Able Marine Energy Park

Material Change 2

Responses to Questions

Aviation Responses to Examining Body ExQ1

Figure 1 Potential Obstacle Lighting Arrangement

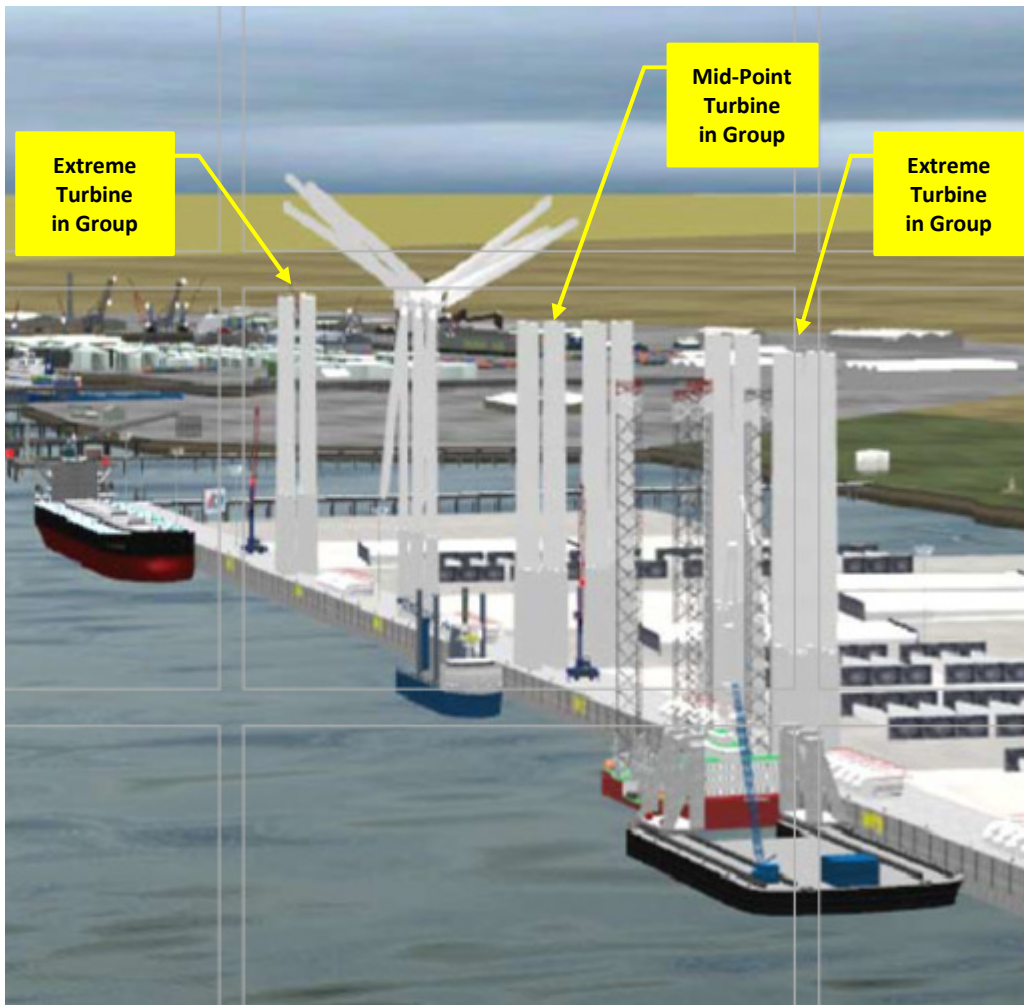
ExQ1: 9.0.2 The photomontages in the original ES show turbines set upright on the site. Should consideration be given to lighting the turbines under construction which, at 165m, are more than 150m agl?

- Given that the Quayside Crane is always present at the site, all UES obstacle lighting and marking recommendations apply automatically to the crane.
- Were full height turbines present on site, **Figure 1** shows a concept visual of the site in operation with several turbine components at the site which also exceed the key 150 m agl level.

- All such full height turbines exceeding the 150m agl level should be lit in accordance with the general rules outlined above.
- It would not be necessary to provide night-time obstacle lighting for all turbine components to comply with best practice guidance.

- However, at a minimum, the extreme turbine components (refer **Figure 1**) should be lit as per the Quayside Crane.
- If the extent of turbine components is sufficiently spread out, the "mid-point" turbine component should also be provided by night-time lighting at its top (medium-intensity red lighting, Type B).

Figure 2 Medium-Intensity Flashing-Red Obstacle Lighting System, Type B

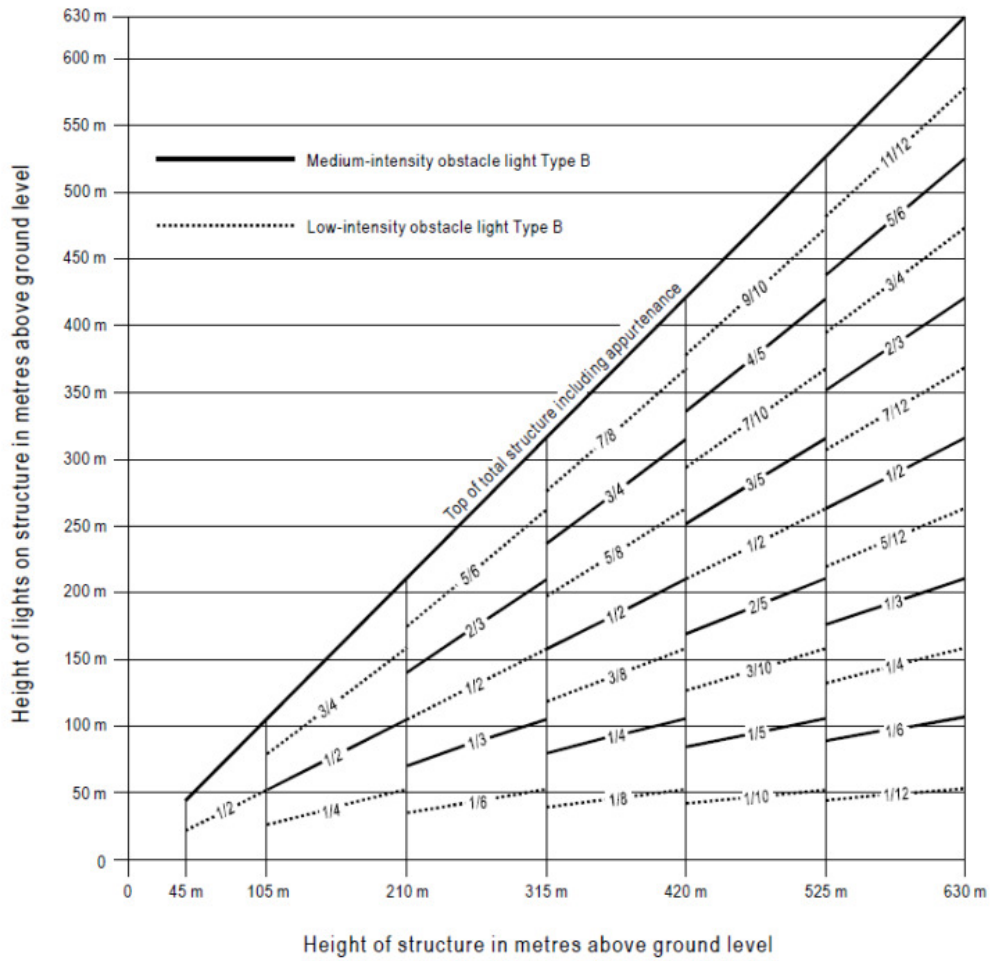
ExQ1: 9.0.3 UES 22.5.6, third bullet, notes that for a crane of height 200m, four levels of lighting are recommended: medium intensity at the top and various intensities at intermediate levels. Would these recommendations be followed? Would there be a different regime for cranes above 200m in height?

Would there be a different regime for cranes above 200m in height ?

Figure 2 illustrates the progression of lighting regimes for structures (including cranes) with height.

- It can be seen that the recommended lighting system for the AMEP Quayside Crane would be suitable for a crane height up to 210 m.
- Above 210 m and up to 315 m, six levels of lighting would be recommended. Additional lighting for even taller structures is shown in **Figure 2**.

Figure 3 Humberside Airport ATC Surveillance Minimum Altitude Chart – ICAO (2018 Update)

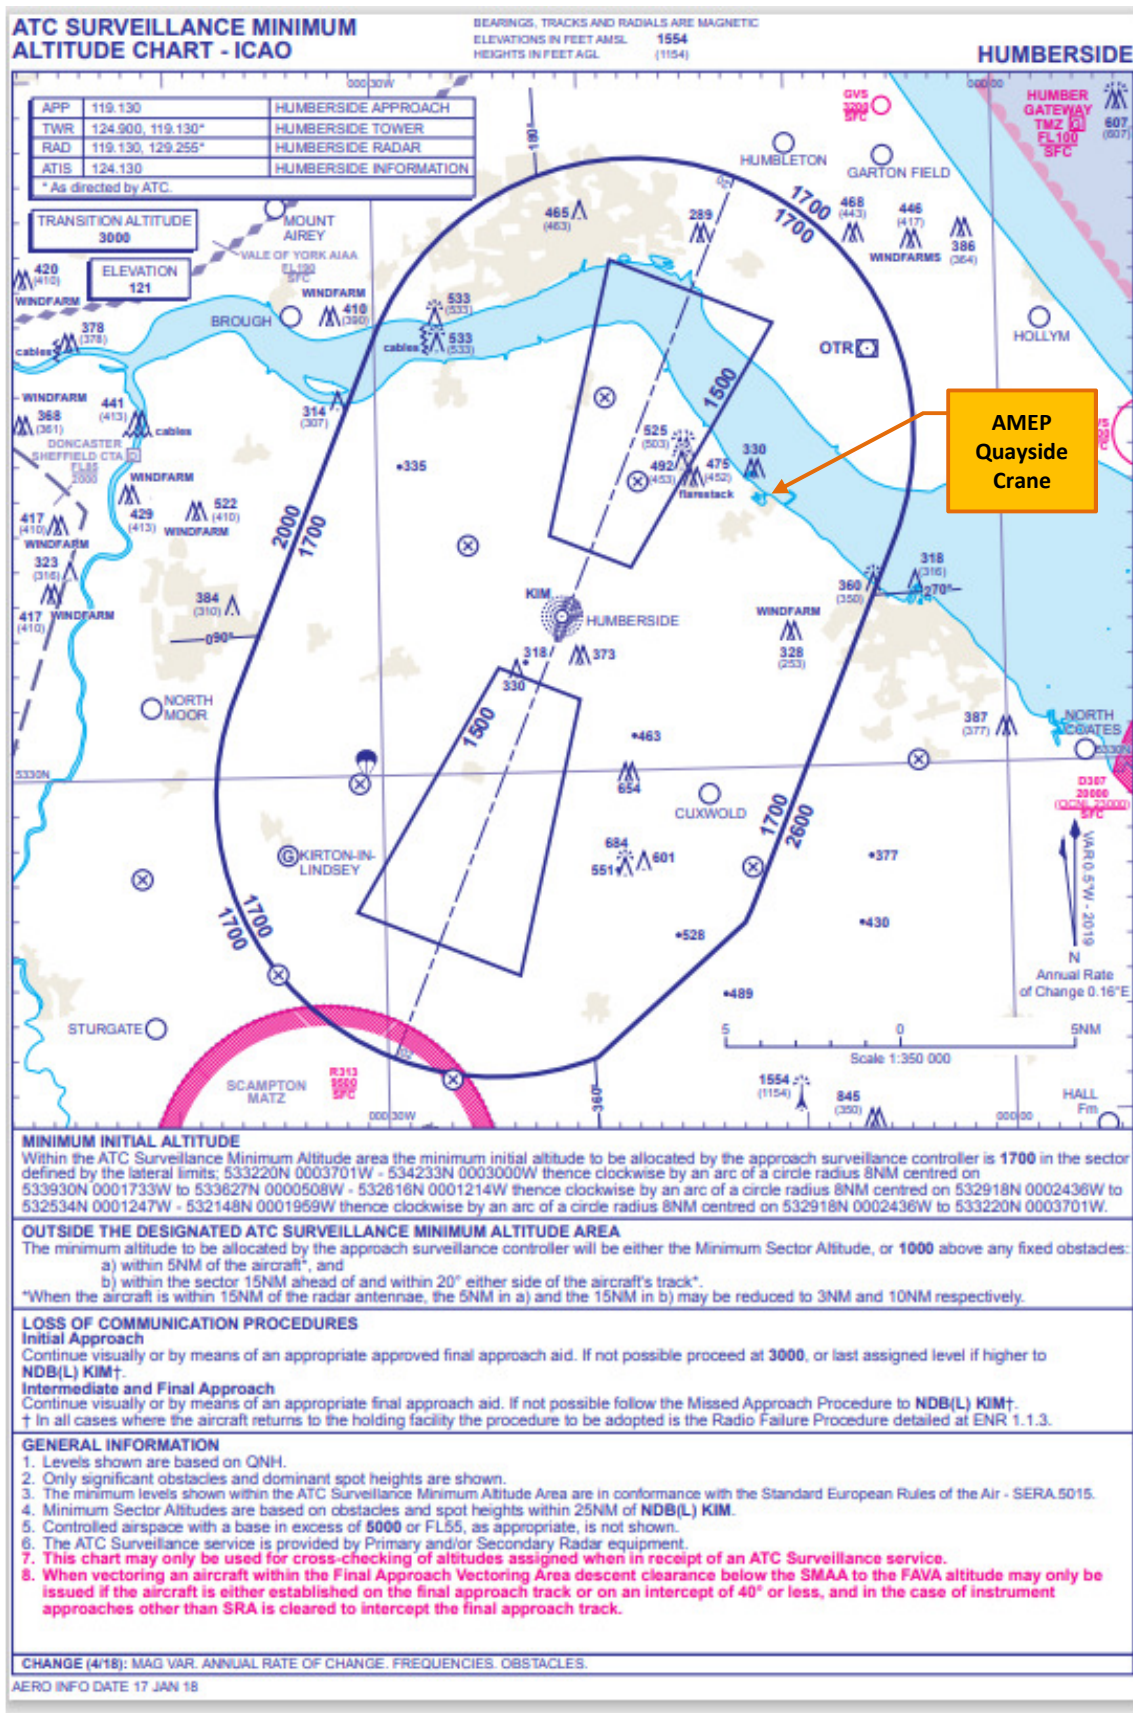
ExQ1: 9.0.4 Has progress been made in consultations regarding the recommended white flashing day-time lighting to the cranes, in addition to the necessary continuous red night-time lighting?

- The displacement of the proposed AMEP Quayside Crane from Humberside Airport's Runway 03 centreline extension is shown in **Figure 3**.
- The surrounds are partly rural in nature and there is potential for daytime nuisance glare on surrounding receivers, including avian disruption.

Accordingly, UES 22.5.6 recommended that consideration should be given to avoiding daytime lighting of the Quayside Crane. Instead, it was proposed that the proposed Quayside Crane could be made conspicuous by its colouring, e.g. employing a colouring pattern with alternating contrasting bands.

Figure 7 Humberside Airport Instrument Approach Chart – ICAO (2018 Update)

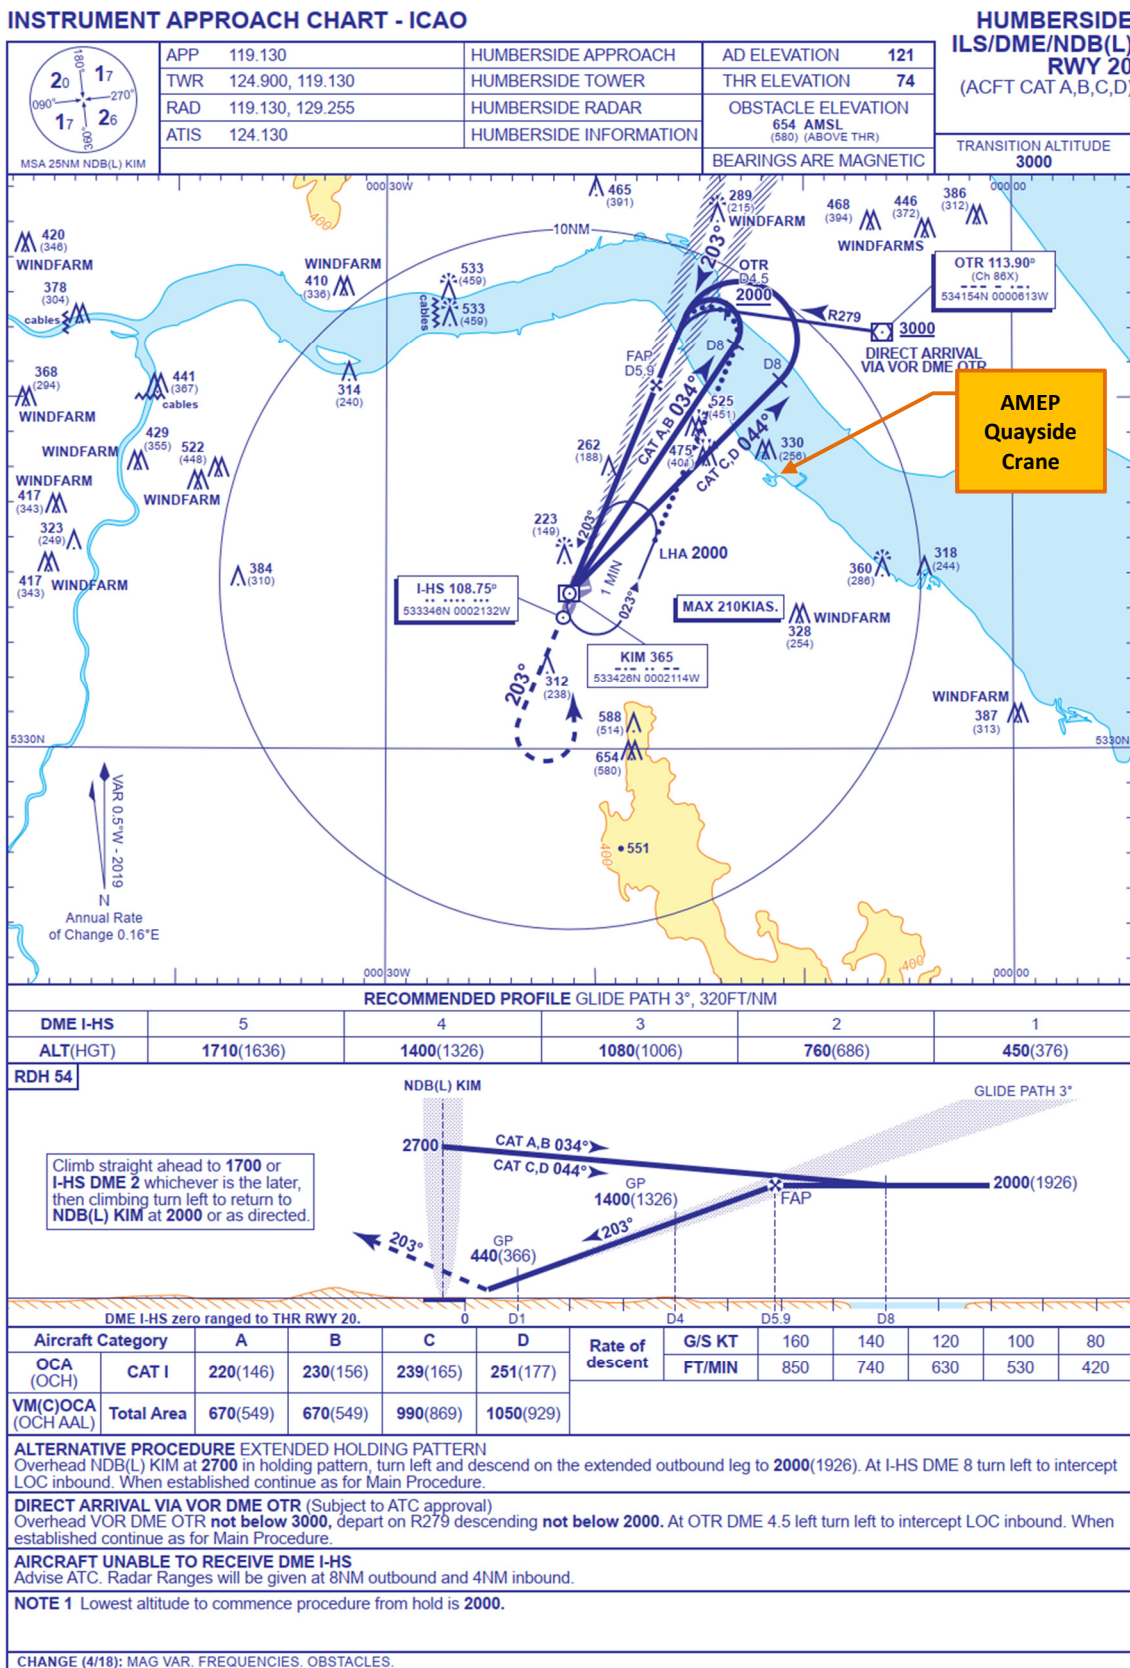
ExQ1: 9.0.6 Has responsibility for incorporating the tall features into air mapping been resolved?

- Addition of the proposed AMEP Quayside Crane to the relevant Humberside Airport (ICAO-compliant) ATC Surveillance Minimum Altitude Chart - refer example in **Figure 3**.
- Addition of the proposed AMEP Quayside Crane to the relevant Humberside Airport (ICAO-compliant) Instrument Approach Chart - refer example in **Figure 7**.
- Addition of the proposed AMEP Quayside Crane to Humberside Airport EGNJ AD 2.10 “Aerodrome Obstacles”, 8 November 2018.
